# Concord Middle School

Middle School Building Committee

VE

15 September 2022

## ITEM #19- Reduce advanced lighting controls from 100% addressable lights to 60%

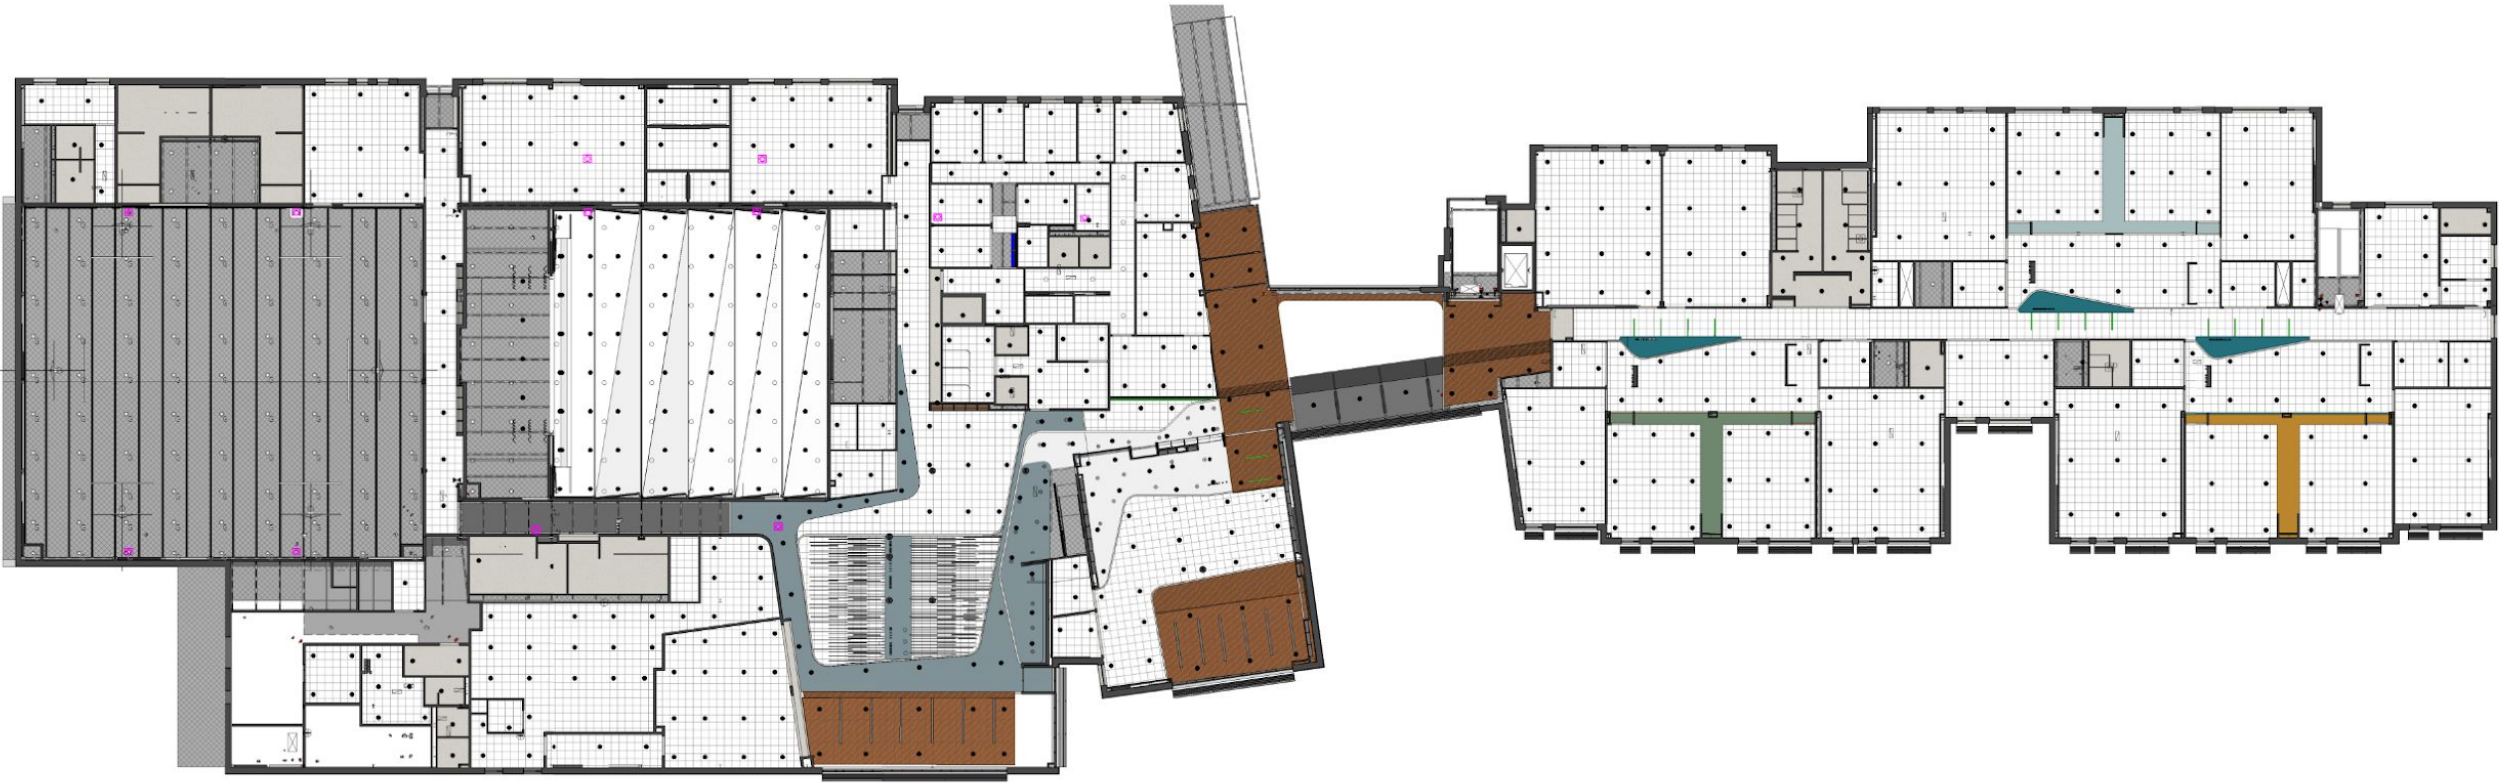
We will replace Enhanced lighting [controls](#) in accordance with [Section C406.4](#)

With

Reduced air [infiltration](#) in accordance with [Section C406.9](#).

This can be Accepted

TYPICAL CLASSROOM

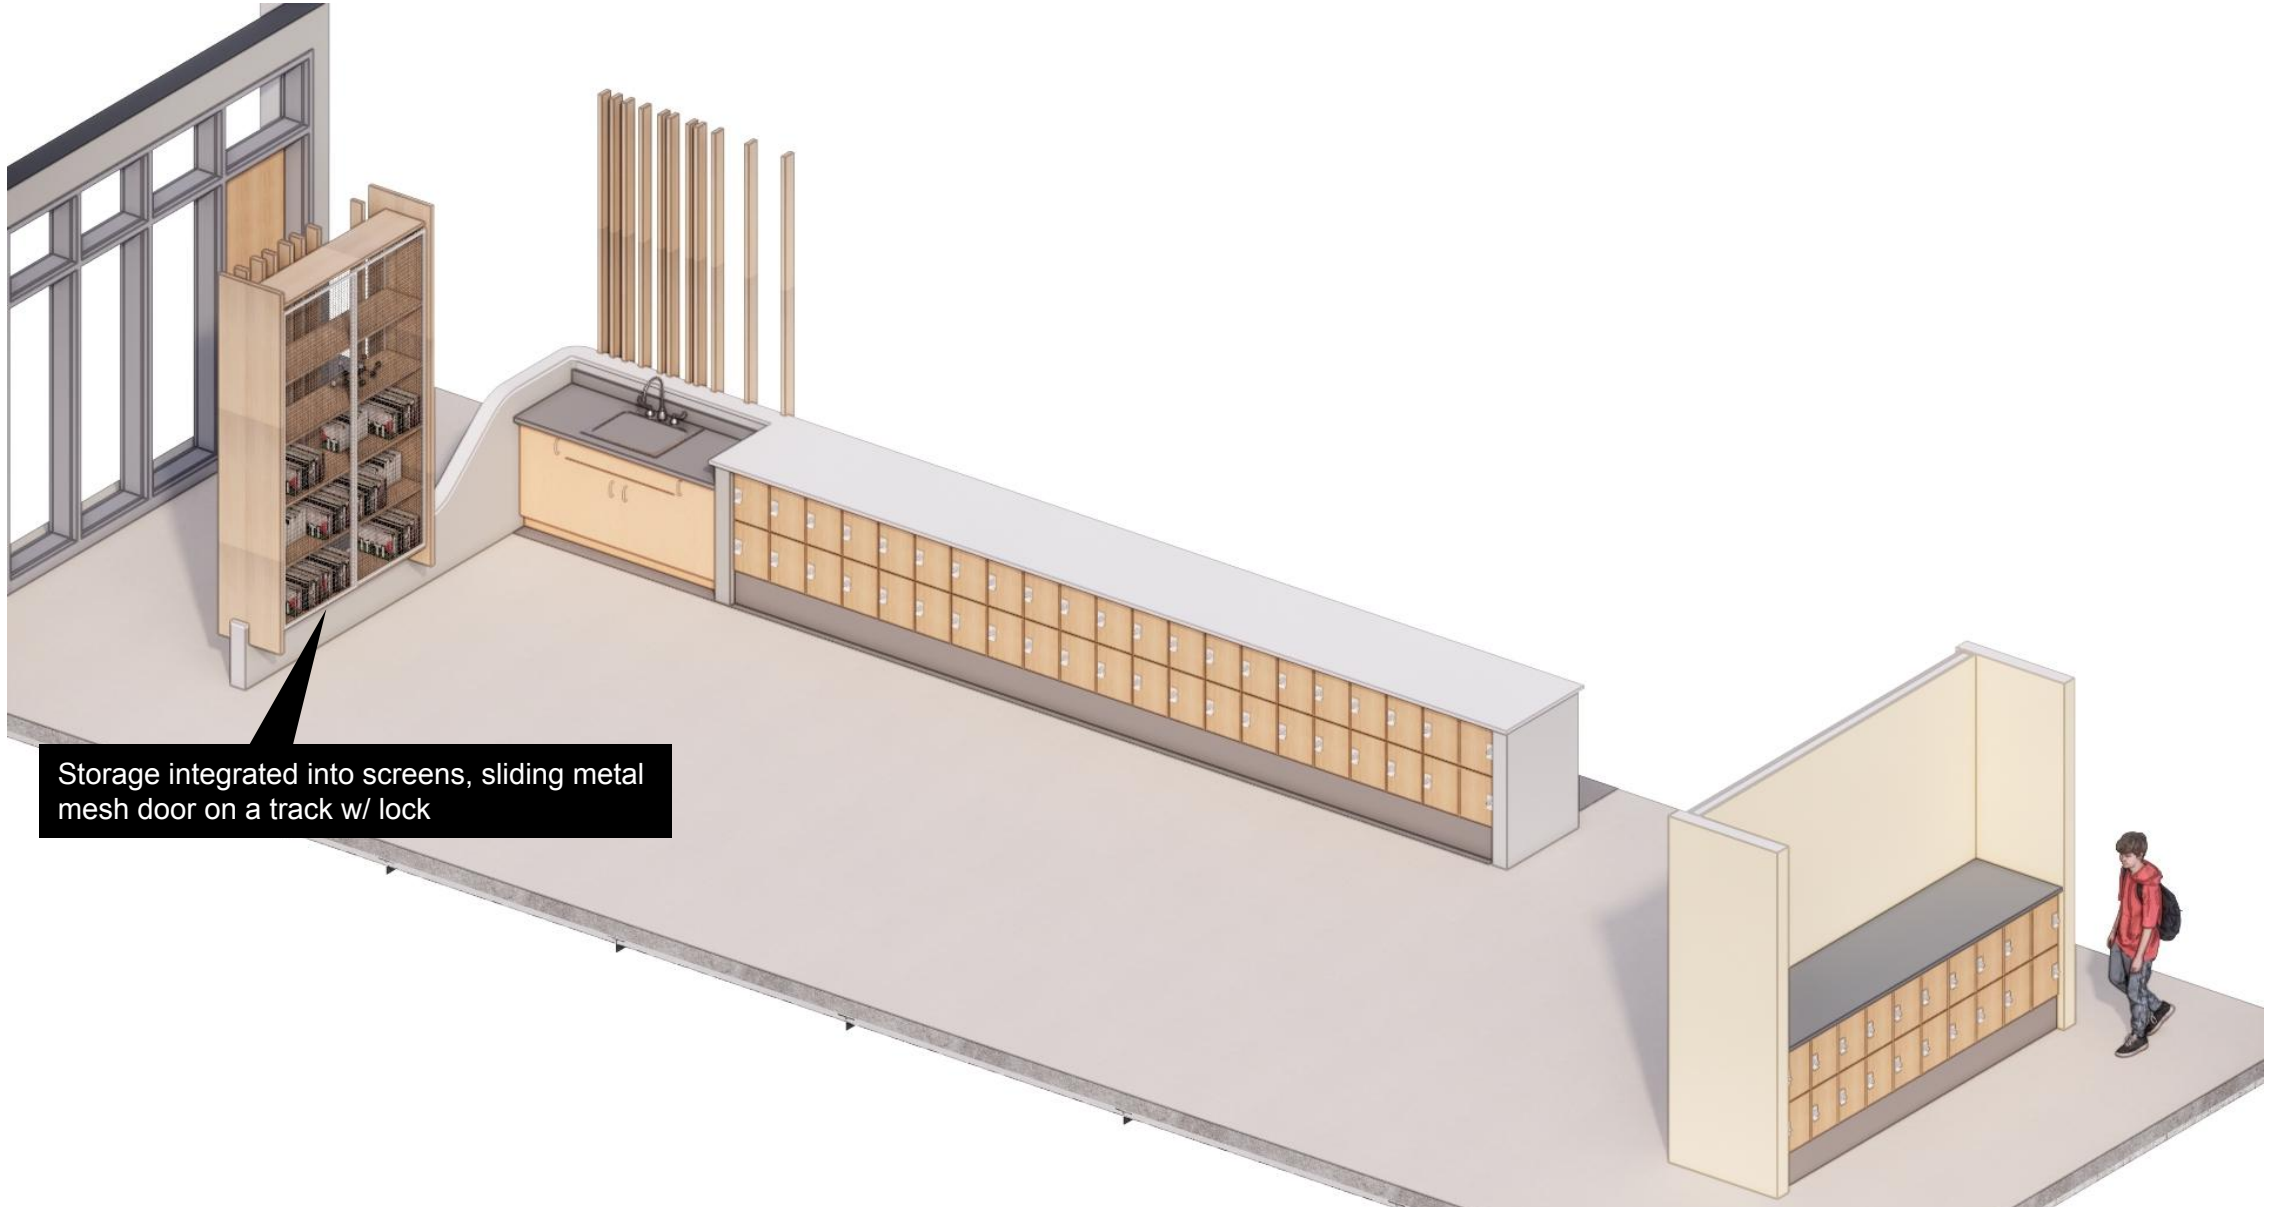
**ITEM #50- Replace folding glass walls at Classrooms into Commons with hollow metal frames and glazing (Maintain folding glass wall at Media Center)**

WET WALL

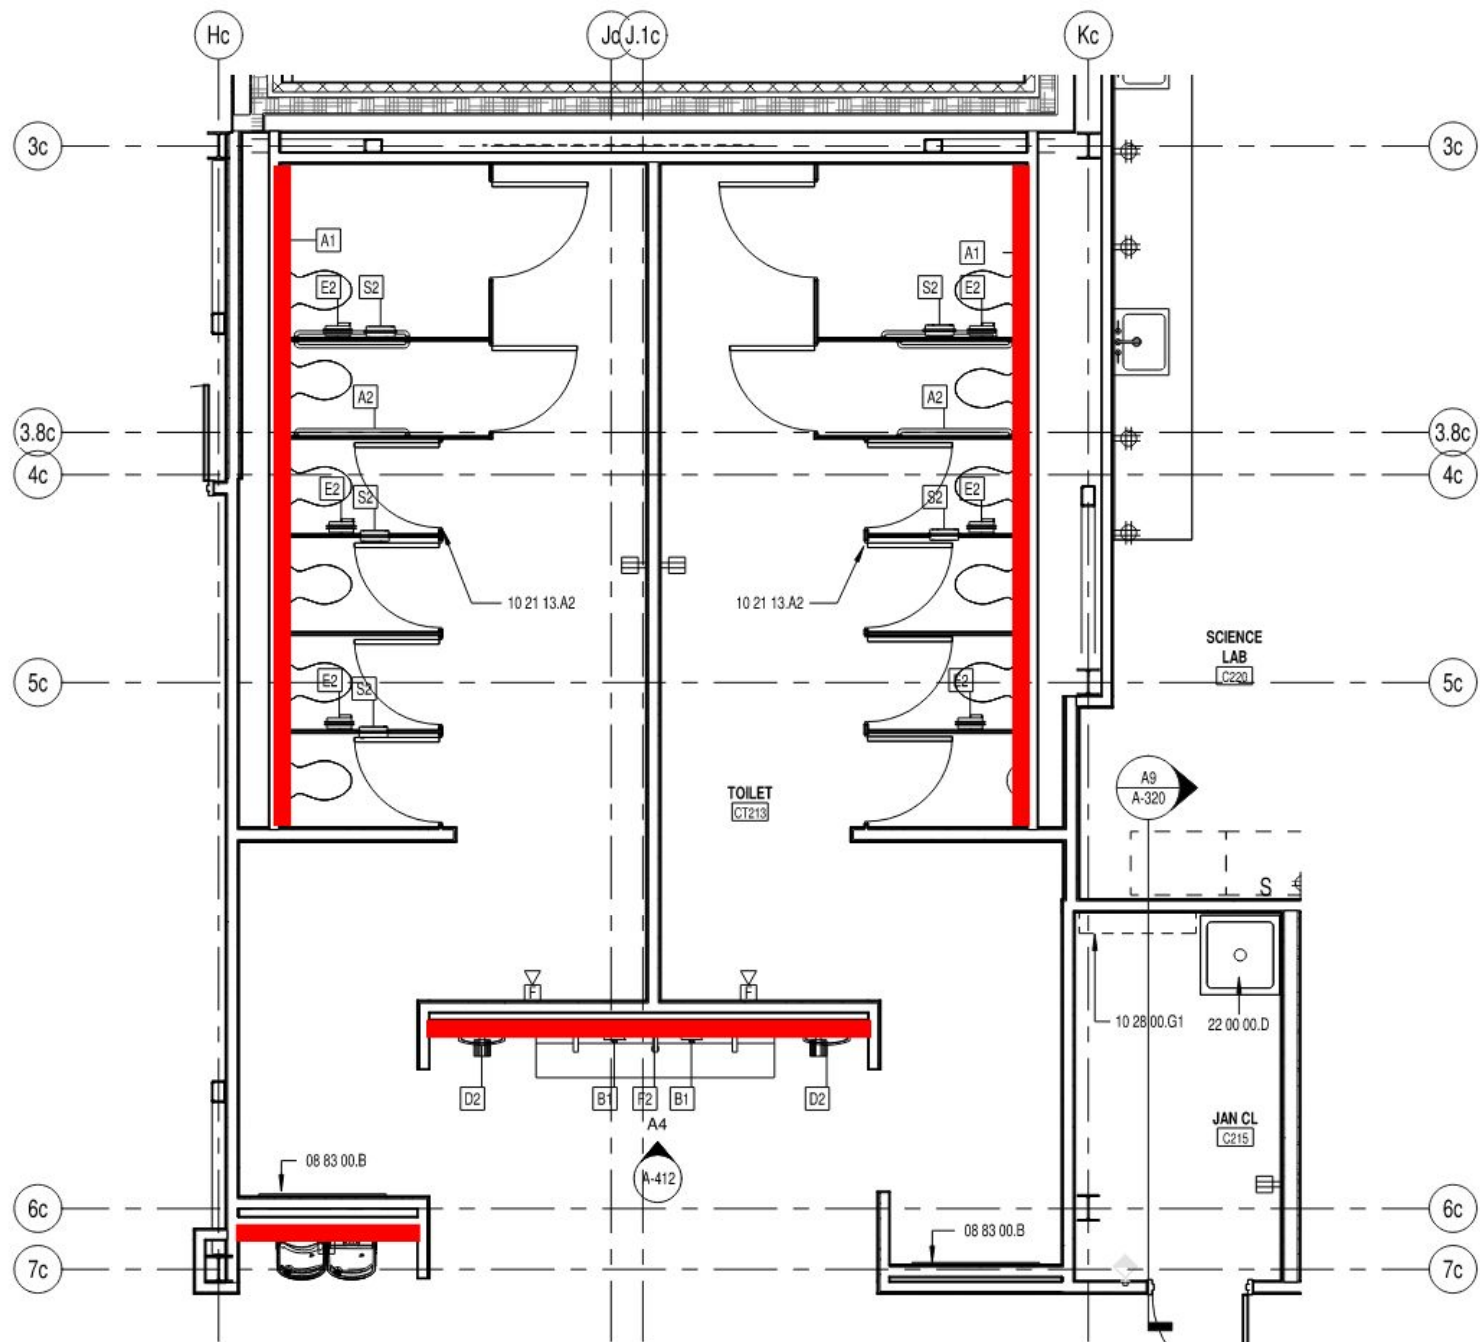
**ITEM #57- Reduce ceramic wall tile in toilet rooms to 8' on wet walls only. Epoxy paint on all other walls**

ITEM #79- Replace granite bollards with concrete filled galvanized steel bollards/ Provide SS sleeve

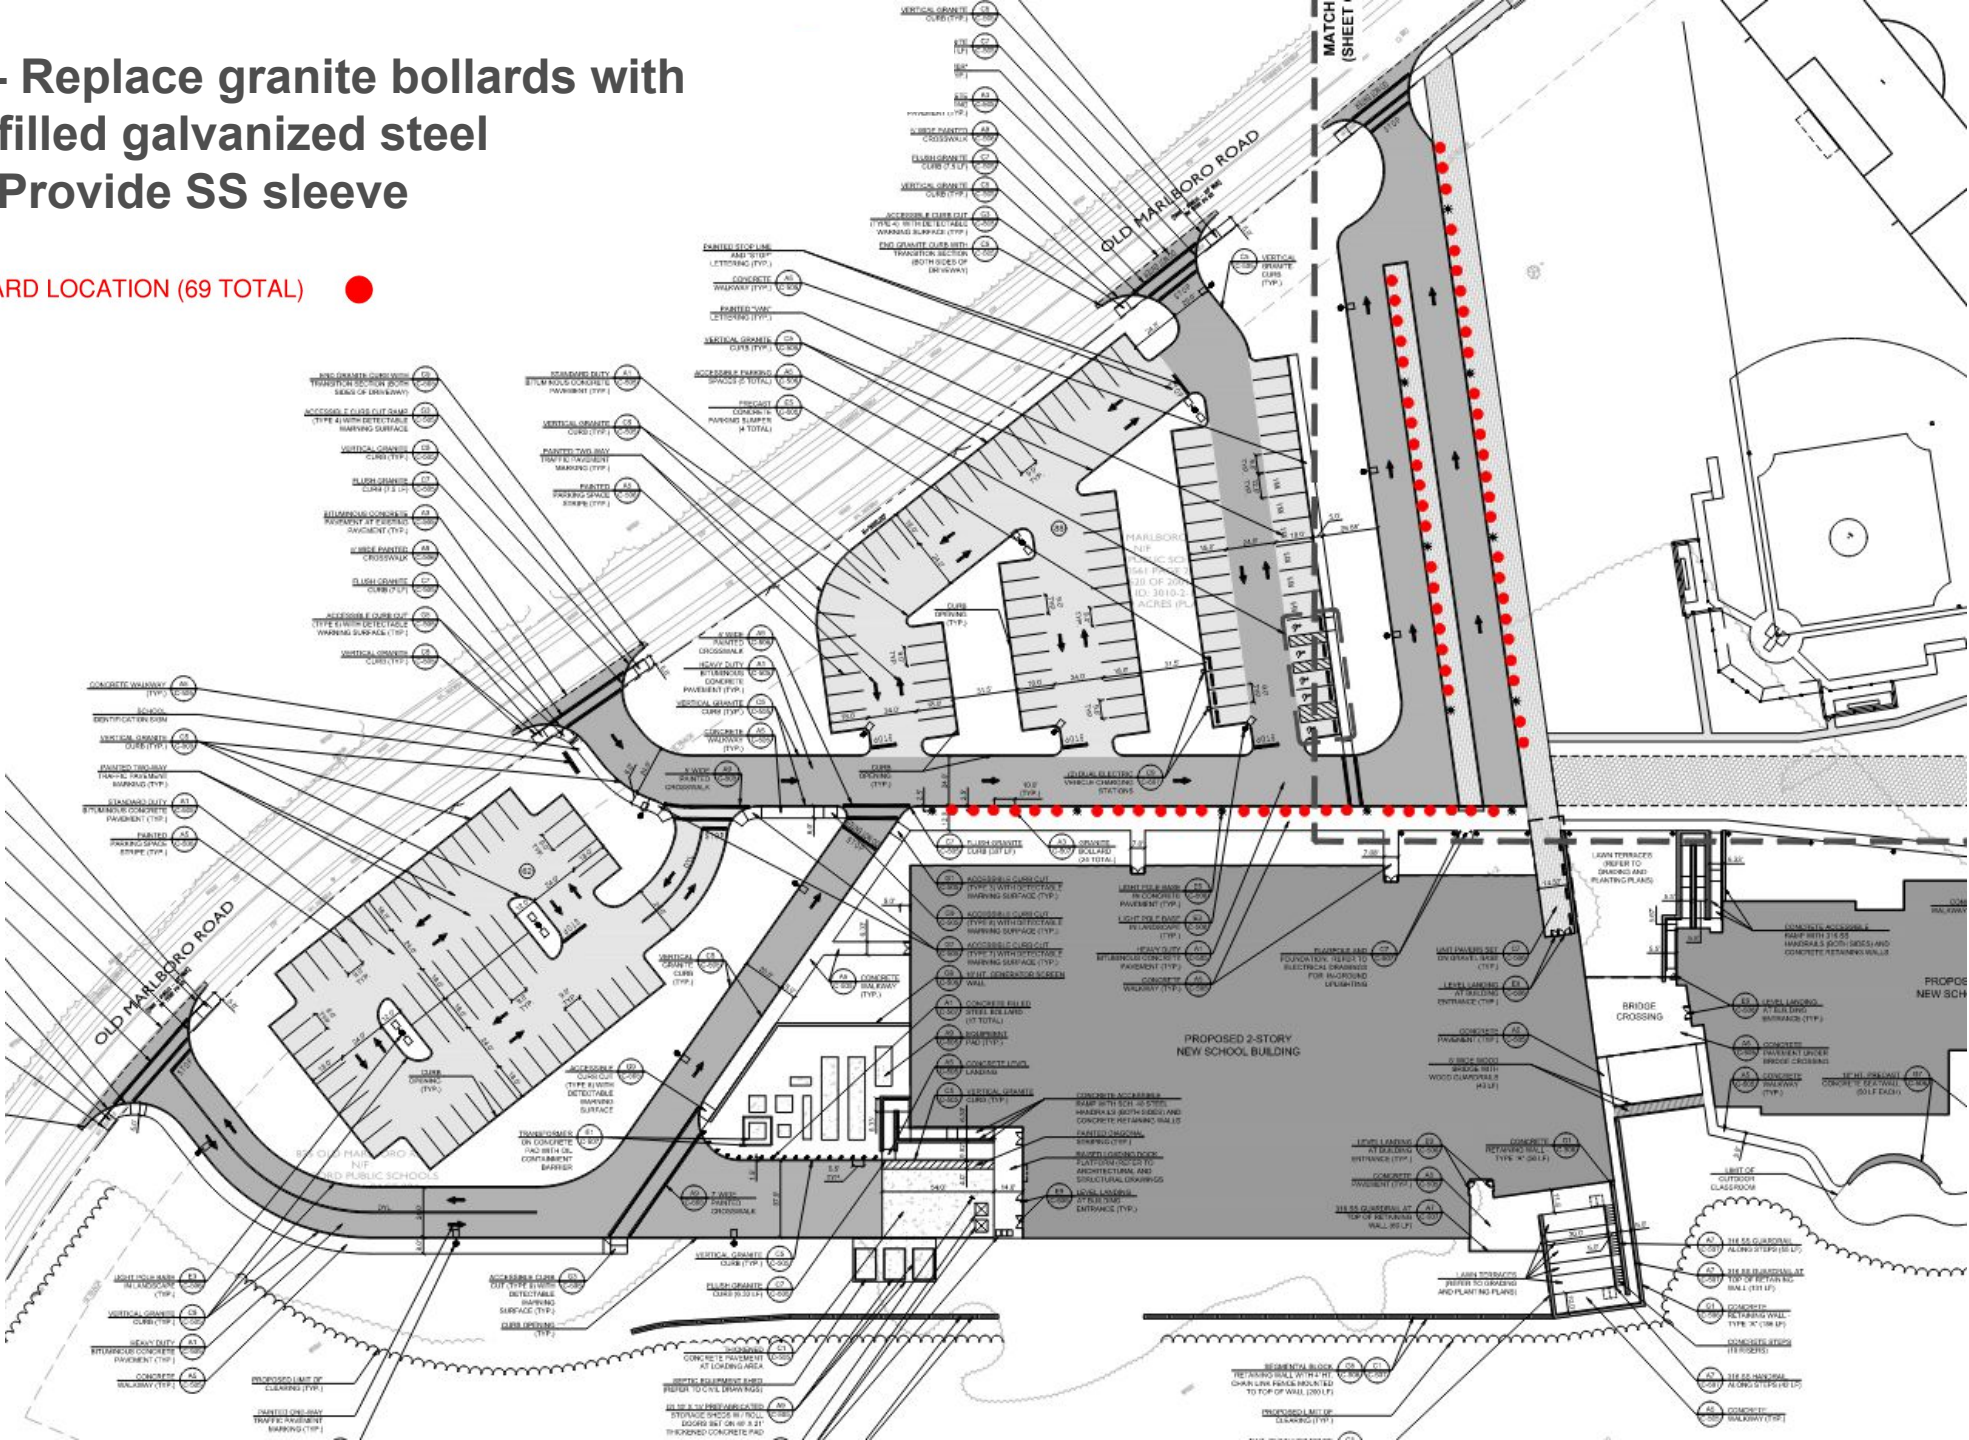
PROPOSED BOLLARD LOCATION (69 TOTAL) ●

# ITEM #80- Remove bevel at CMU exterior walls

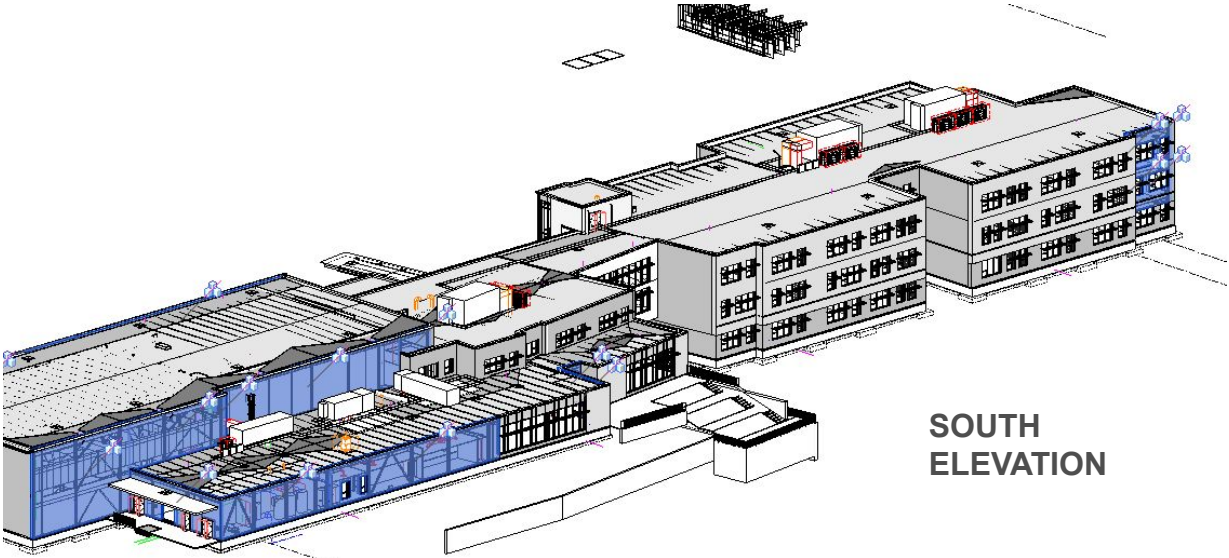
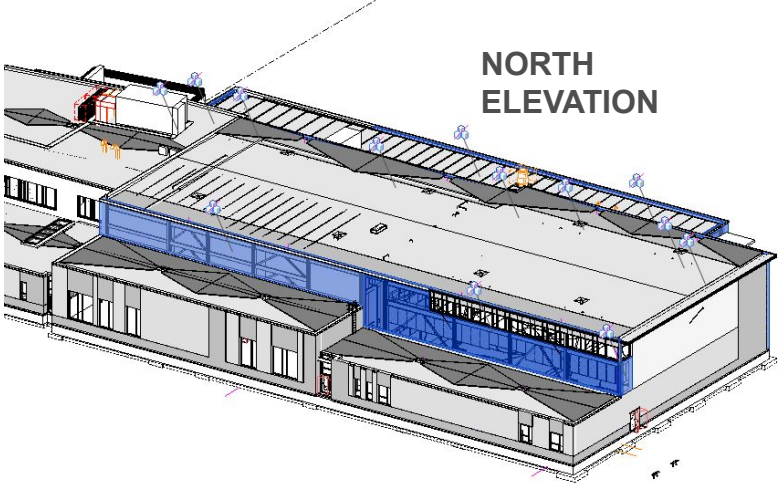
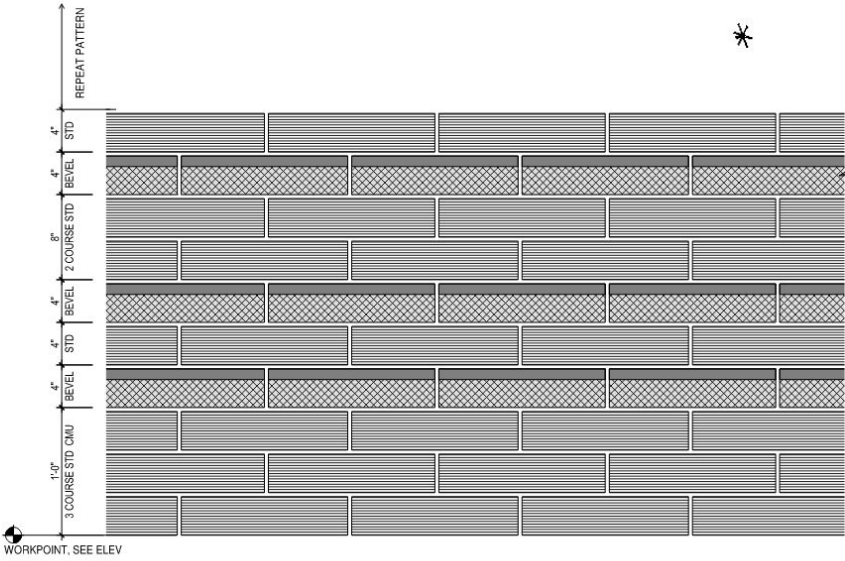
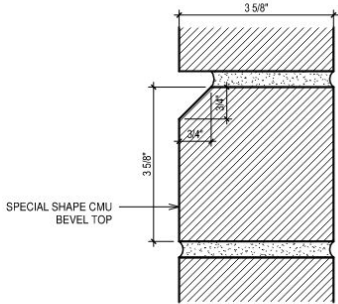
BEVELED CMU COURSE  
SEE: A3 / A-210
